TO: Members of the MAG Standard Specifications and Details Committee

SUBJECT: MEETING NOTIFICATION AND TRANSMITTAL OF TENTATIVE AGENDA

MAG Standard Specifications and Details Committee
TENTATIVE AGENDA
July 6, 2016

236-3

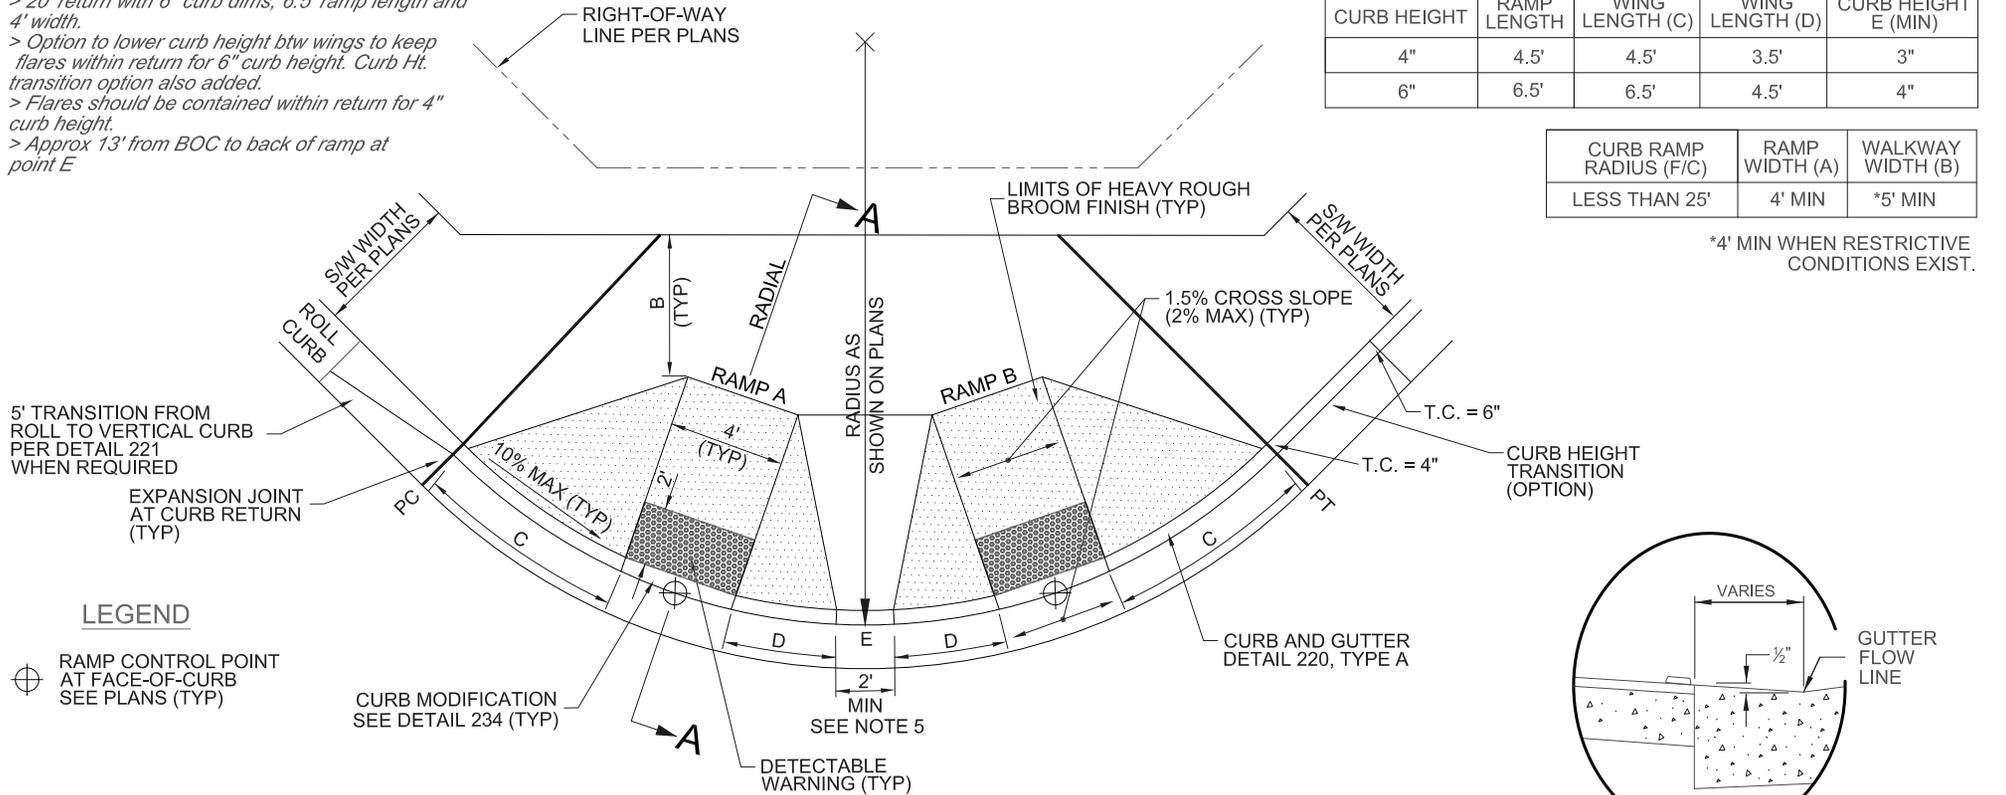
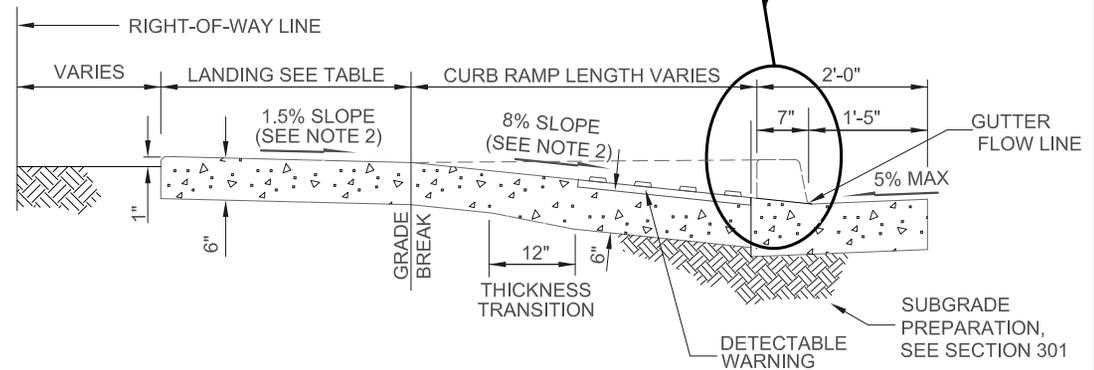
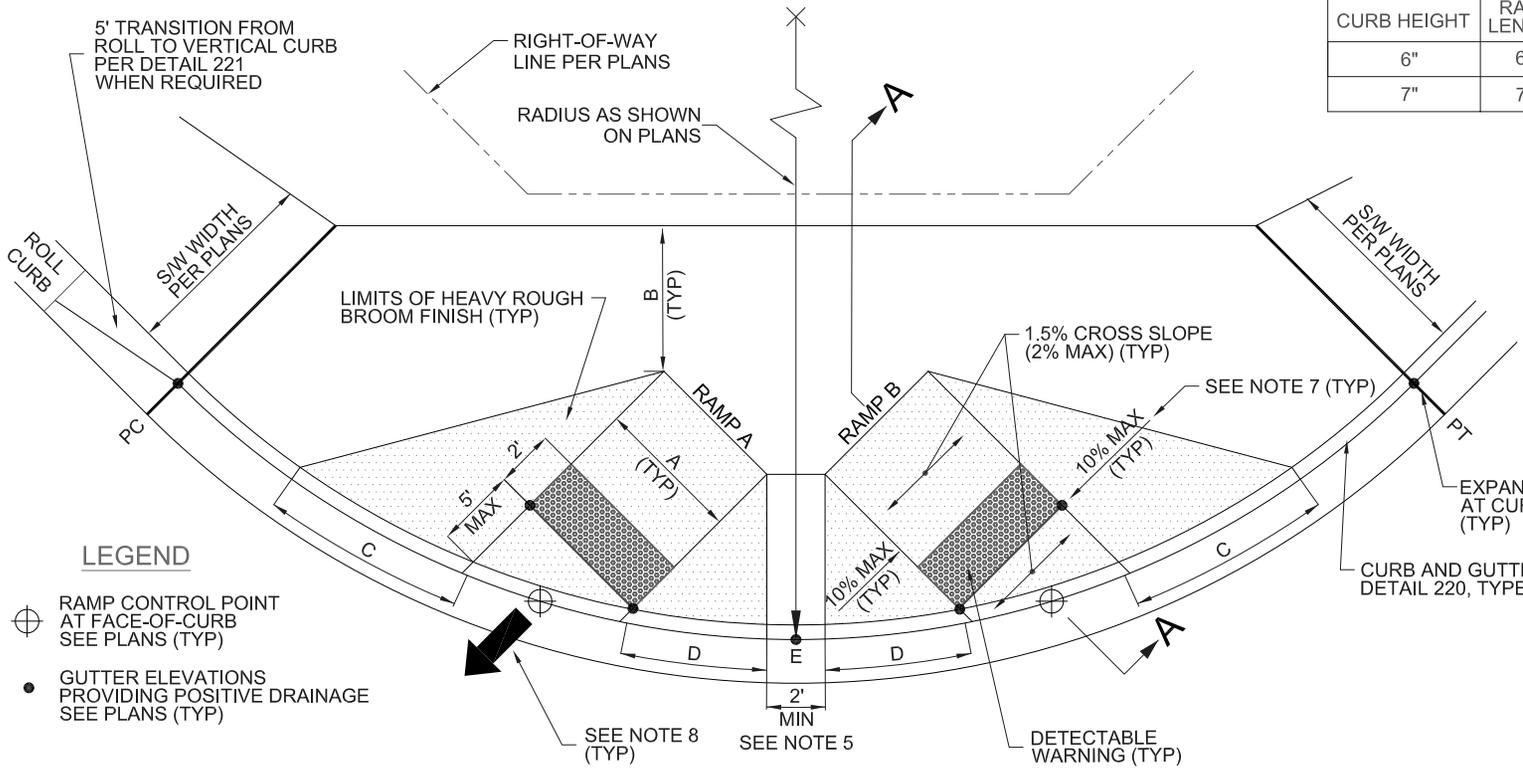
One of the first areas Mr. White wanted to discuss was the maximum slopes vs. the preferred slopes, and whether to show both on the detail as currently shown on the draft details. Mr. Herz recommended removing the maximum slopes from the details since they are in the specifications, and you want contractors to use the preferred slopes to allow for construction tolerances. Mr. White said workers in the field may not have the specs available. Tom Kaczmarowski recommended to leave it as is, but add a note on where the max values came from. Paul Nebeker said the workers in the field often only have the drawings and the details should lead them back to the specs. Mr. White said this was true for inspectors as well. Rod Ramos said he thought it should be clear in the specifications that if the maximum slope values were exceeded, the ramp needs to be removed.

Peter Kandarlis commented on the tables that added (TYP) to the dimensions for C and D. He said typical does not mean approximate. Rod Ramos gave the example where on the wings it says 10% MAX TYP, means that the other ramps are 10% MAX slope, not that it is typically 10%. Bob Herz suggested changing the C and D dimensions “varies.” Mr. White said that's what they ended up doing on Chandler's details. Mr. Ramos said they show all spot elevations at Scottsdale and said the dimensions of the wings need to be calculated. He said that you can't have a one-size fits all detail. It needs to have an engineer determine the sizes. Brian Gallimore said contractors would like a little flexibility in construction, and allow the curb heights to

- General revisions from working group discussion including adding Legend, Ramp A/B label, revisions to table headings and lengths. Section A-A revised to reference Note 2 and 12” Transition Thickness clarified.
- Added Details 236-3 and 237-3 for 20 ft return and options to keep wings within return. Revised detail series titles for 25’ to 35’ radii and 20’. Have not yet added detached detail for 20’ R (TBD).
- No changes to Section 340.3.9 Tolerances from previous package.
- Added revisions to Section 340.5 Measurement provided by Bob Herz. Mainly clarification of measurement for types of curb ramps and number of curb ramps contained within the return.

DETAIL NO.
237-1

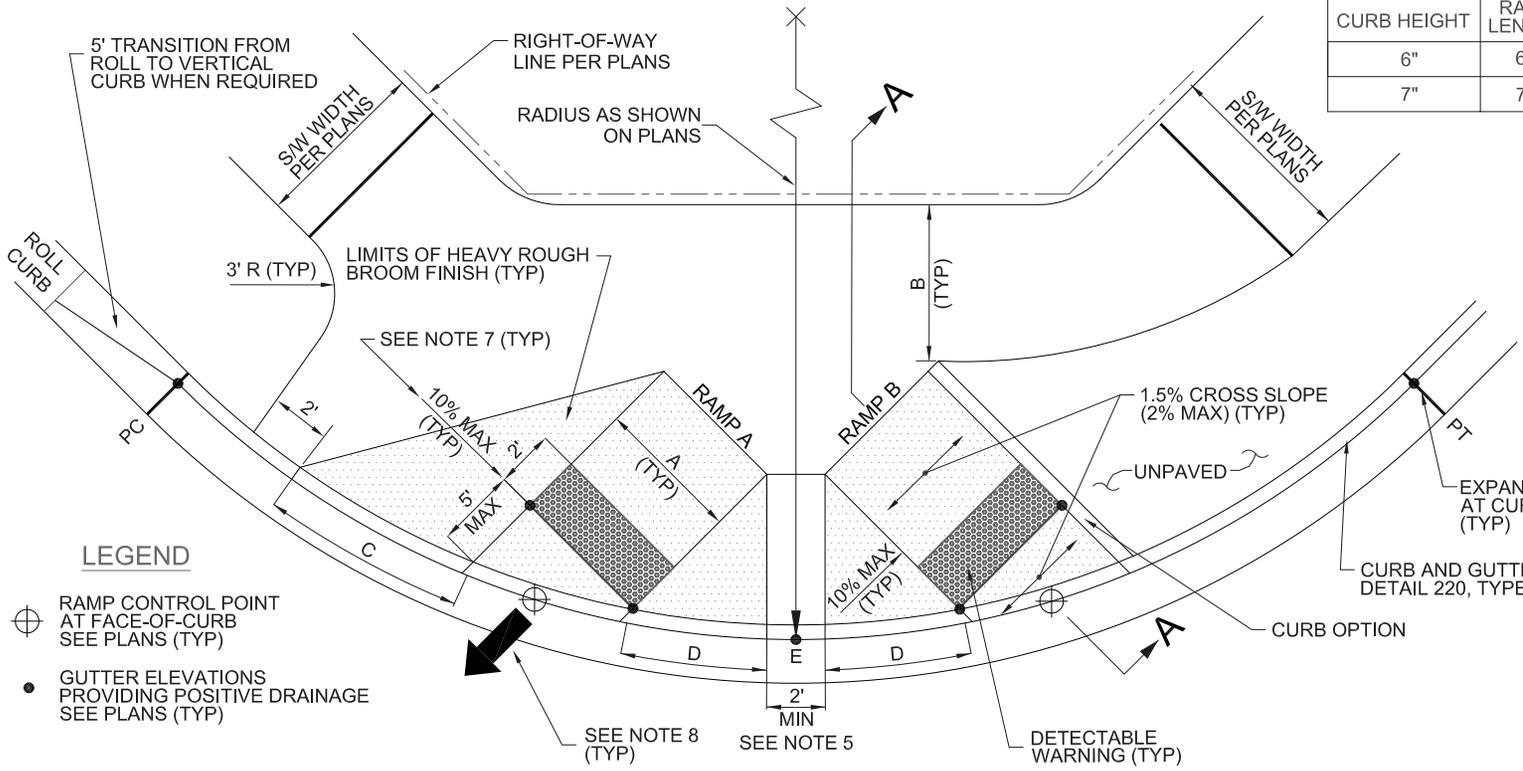
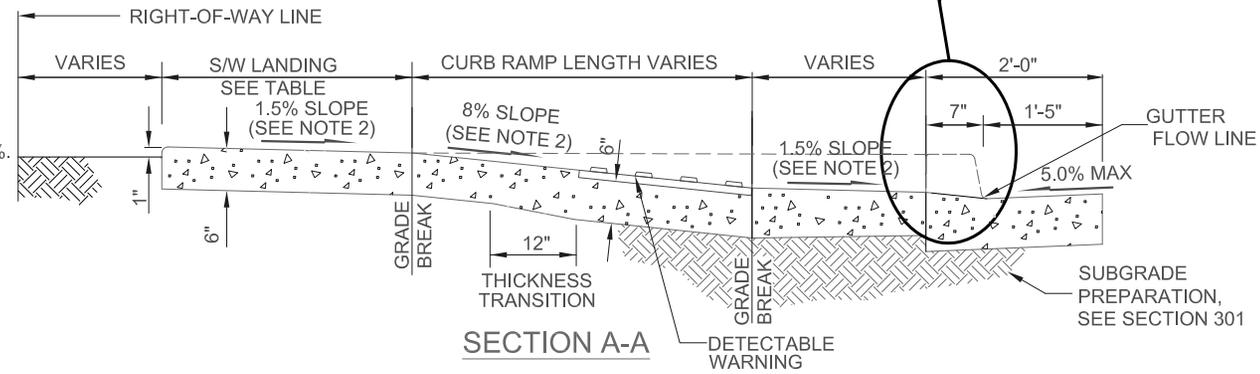
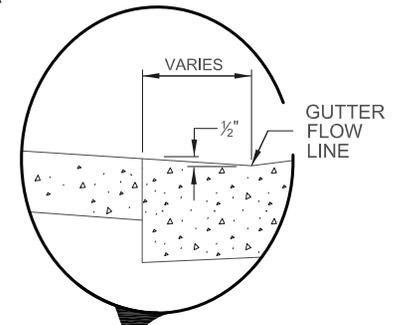
Mr. White next said the control points were moved to the face of the curb to match Detail 234. The directional ramp details also added note 8 "Ramp alignment should connect control point to control point of receiving ramp within 5 feet" which is needed for a blind cane user to detect the ramp. Other changes included allowing a walking space behind ramps as 5' preferred to match MAG sidewalks. ADA has a minimum of 4' when there are restrictive conditions. Steve Ketchum thought this seemed a reasonable approach.

DETAIL NO.
391-2

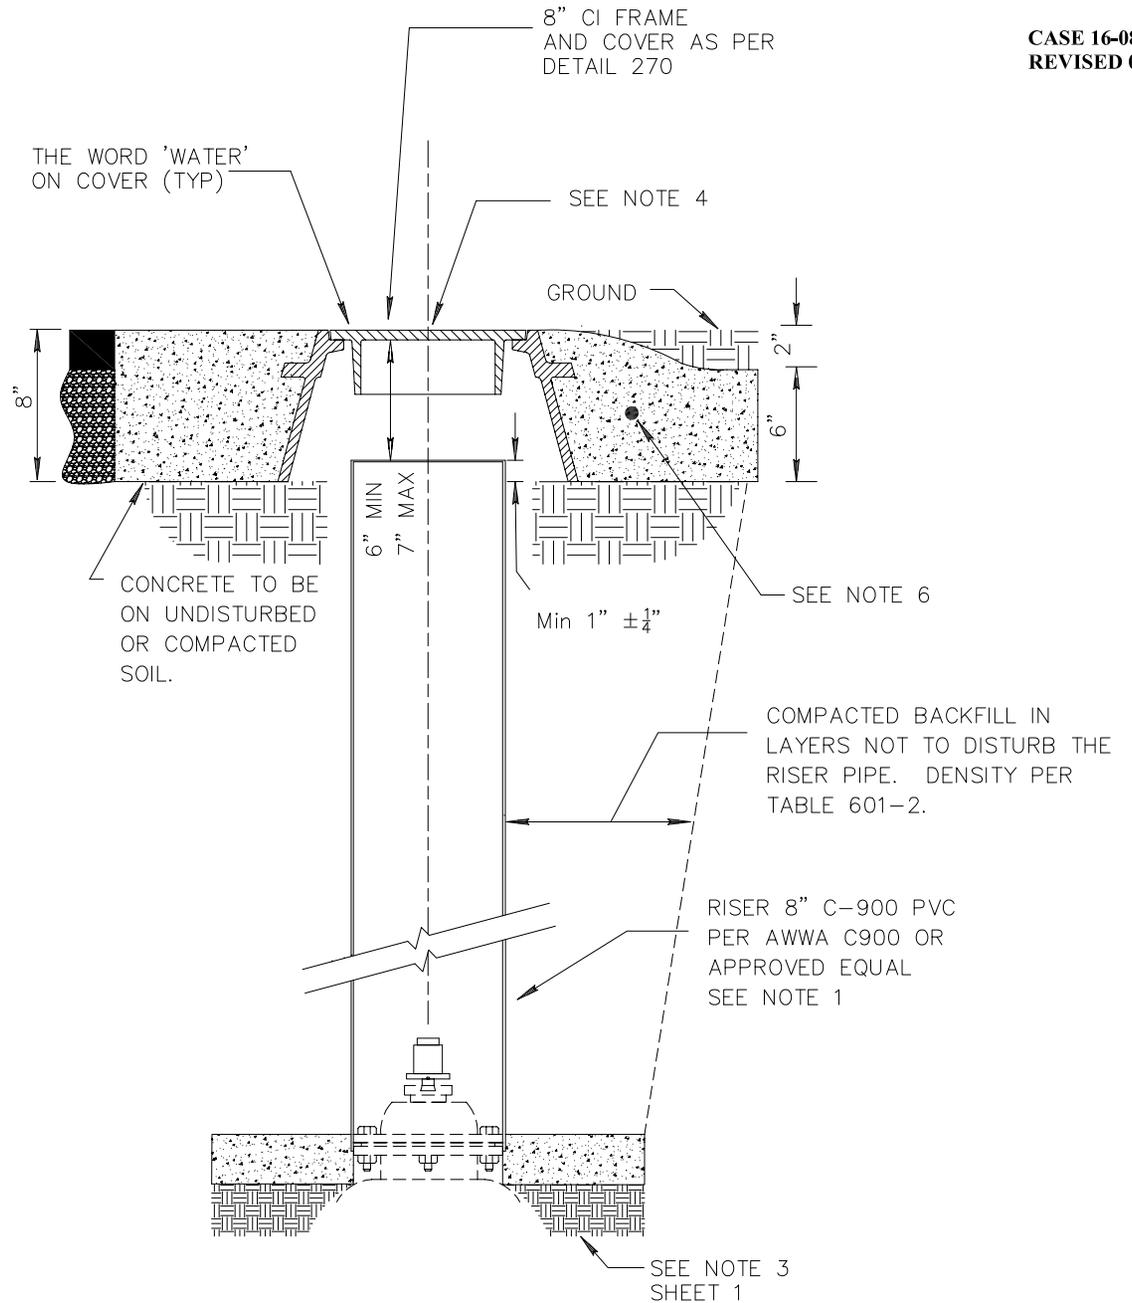
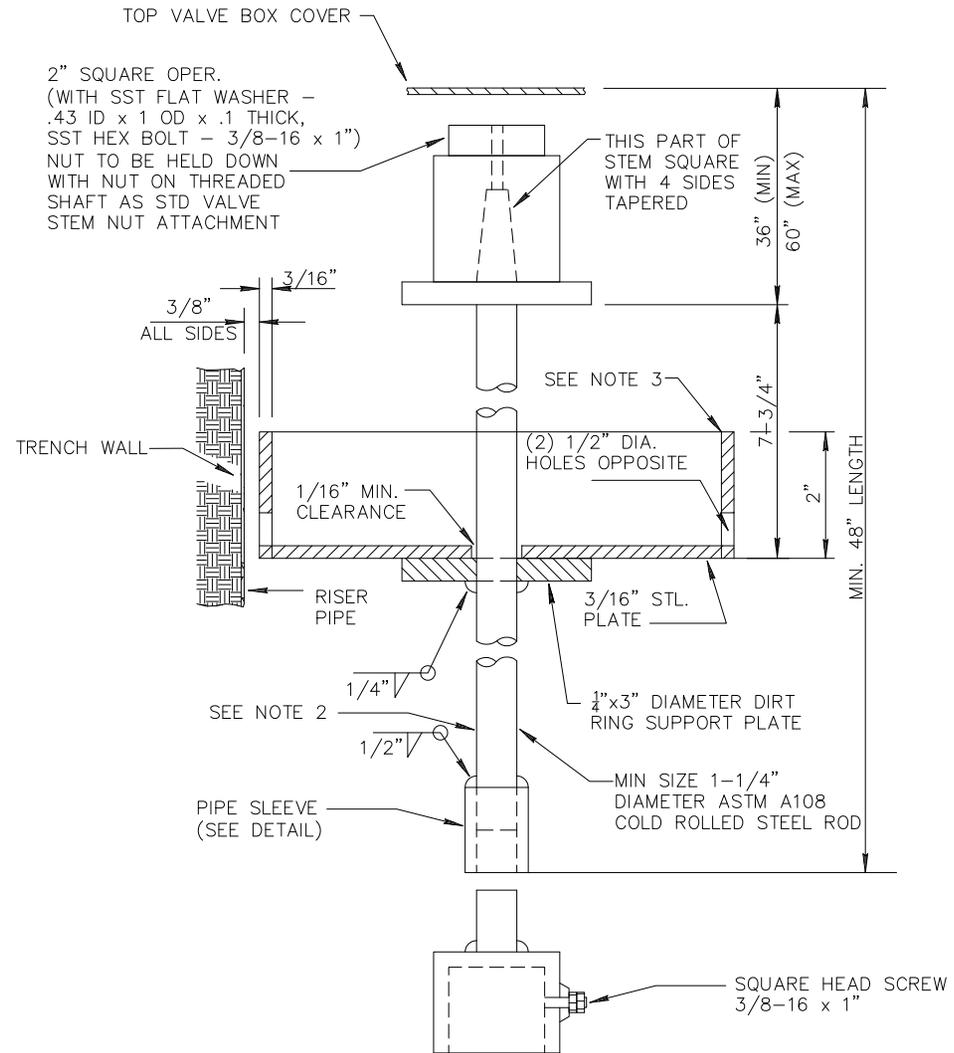
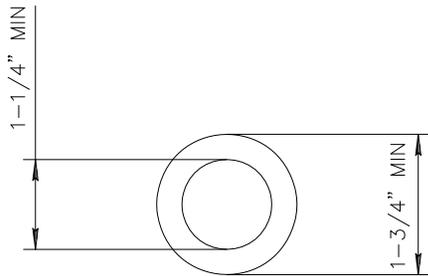
Rob Duvall said that on Detail 391-2, Notes #2 and #6 duplicate notes on the drawing. They could be references as “See Note #2” as an example. There was also a missing arrow for the frame and cover note.

DETAIL NO.
310

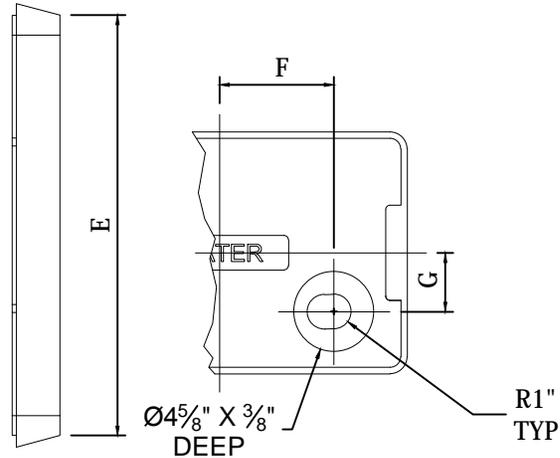
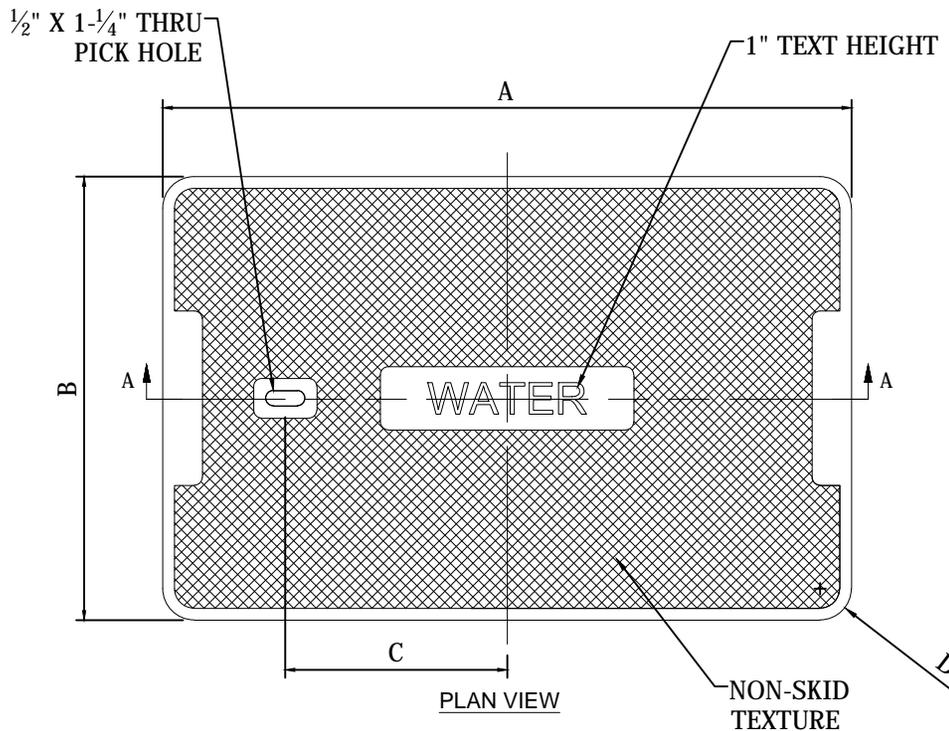
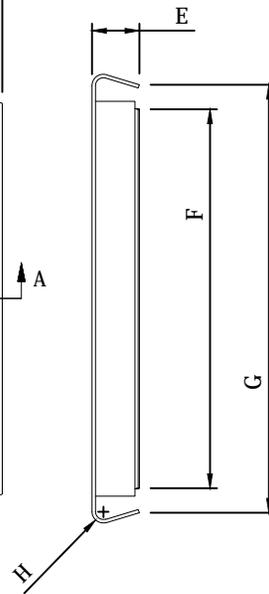
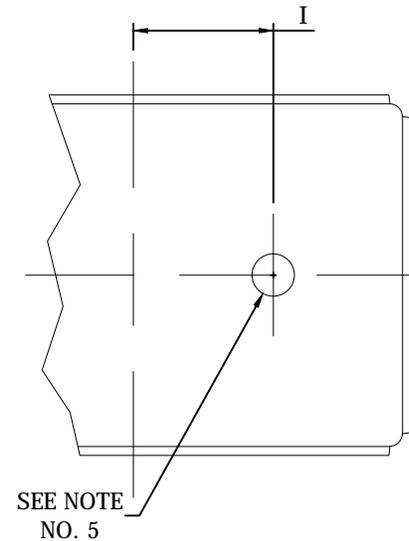
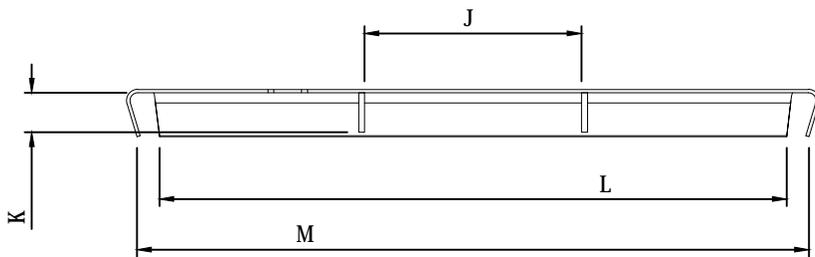
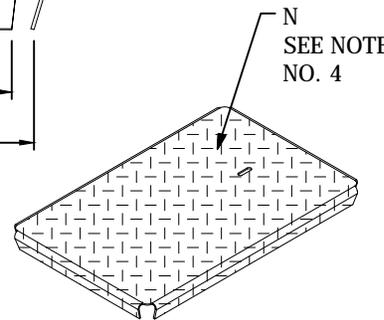
On Detail 310 it was suggested to label dimension J as 2" since it is the same for all sizes. Mr. Tyus suggested stating what the ASTM A786 reference in Note 1 was referring to. The polymer lids (Detail 315 have a slotted AMR hole to allow it to work universally.

- Note 1 – lid material per ASTM.
- Added notes 4 and 5.
- General cleanup, removed letter J and shifted all other letters accordingly.
- Revised A and C dimensions to allow for 1/8" gap on each side.
